<b>T.I. no.:</b> 2025-09 Updated: -	<b>Topic:</b> Replacement of retaining plate (3370067942)
--	---

<b>Date:</b> 6/10/2025	<b>Priority and need for action</b>	
<b>Affected machines:</b> SOUL	<input type="checkbox"/> High: as soon as possible	
<b>From production date:</b> 12/1/2024	<input checked="" type="checkbox"/> Medium: next visit	<input checked="" type="checkbox"/> Medium: change in stock
<b>From date:</b> right away	<input type="checkbox"/> Low: FYI only

Figure 3: Retaining plate with welded-in welded bolt

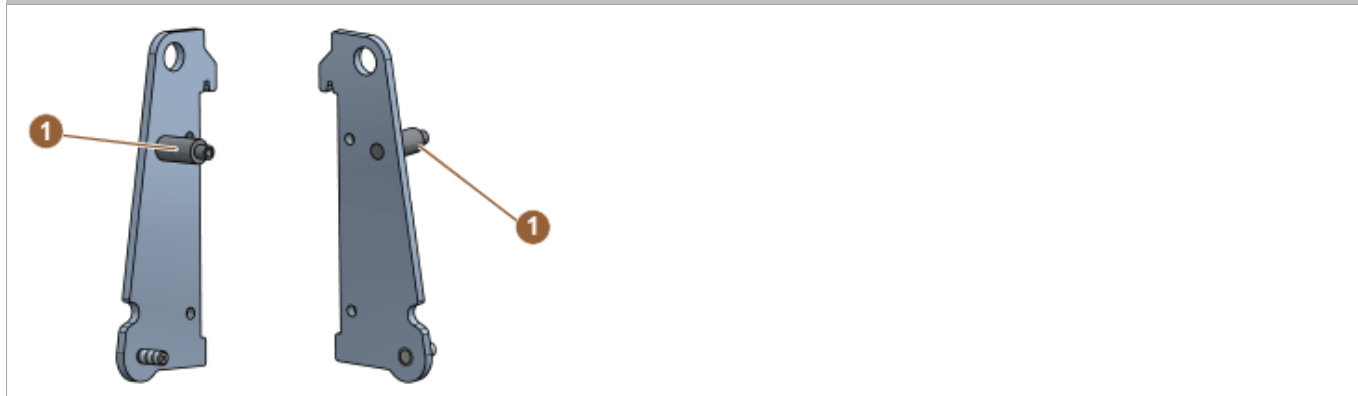
We have received feedback from the field that there have been problems with the 7-mm welded bolt (metal pin) for the retaining plate (article number 3370067942). The weld seam for the welded bolt is too weak, which means that the welded bolt can break off under excessive load. This causes problems when opening and closing the user panel.

**Figure 1:**  
 NEW: Retaining plate with reinforced weld seam.  
 The welded bolt remains stable.

**Figure 2:**  
 PREVIOUS: Retaining plate welded bolt, with weaker weld seam.  
 The welded bolt can rip out.

The welding process has since been corrected and optimized. The weld seam has been reinforced to ensure the stability of the welded bolt.

- ▶ Replace the retaining plate.

- ▶ Check the stock levels and replace with the new retaining plate if necessary.
